Origination Form
Proposed Revisions to a Standard Plans Index

Originator:	Pinkham, Andrew	Index Number:	430-030
Date:	6/3/2025	Sheet Number(s):	2
E-mail:	andrew.pinkham@dot.state.fl.us	Index Title:	Straight Concrete Endwalls Single and Multiple Pipe

CONCRETE ENDWALL DETAILS

DETAIL "B"

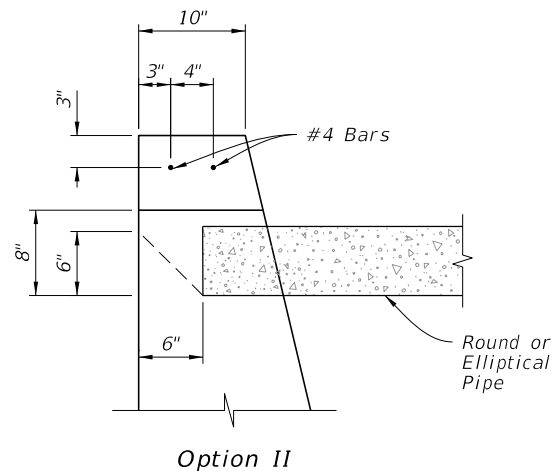
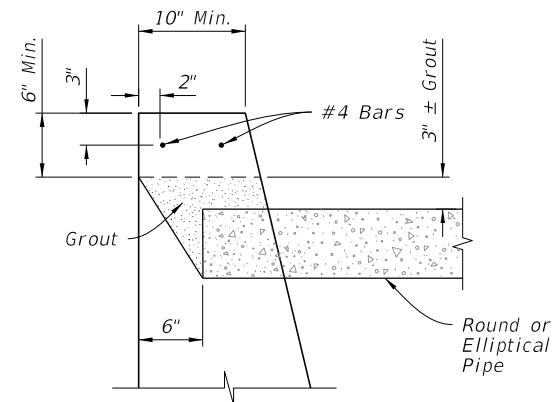
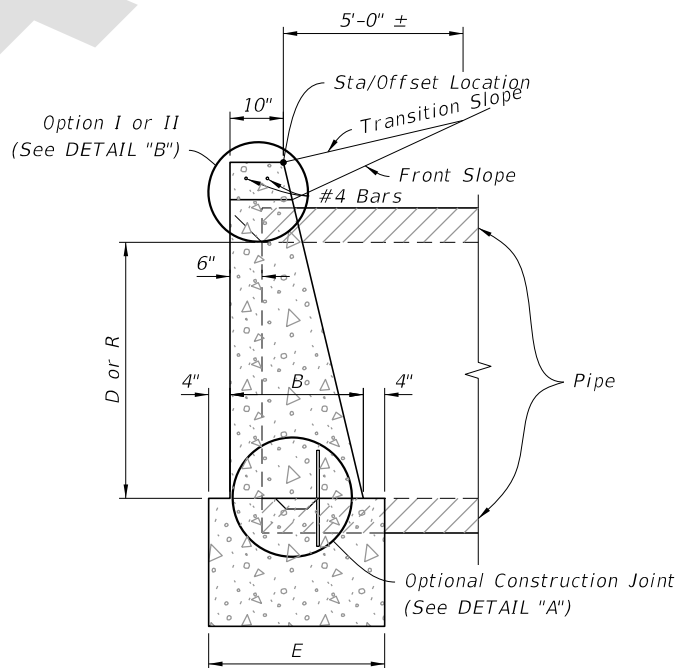
Sheet 2: Added DETAIL "B" to show Option I or II.

Addition of alternate to hole forming details and minimum beam height above the opening. Issues with delivered product and at request of Industry. Request came through the Precast Concrete Structures Association to Andrew Pinkham at SMO, through Drainage Design and was signed as an Approved Shop Drawing by State Drainage Engineer.
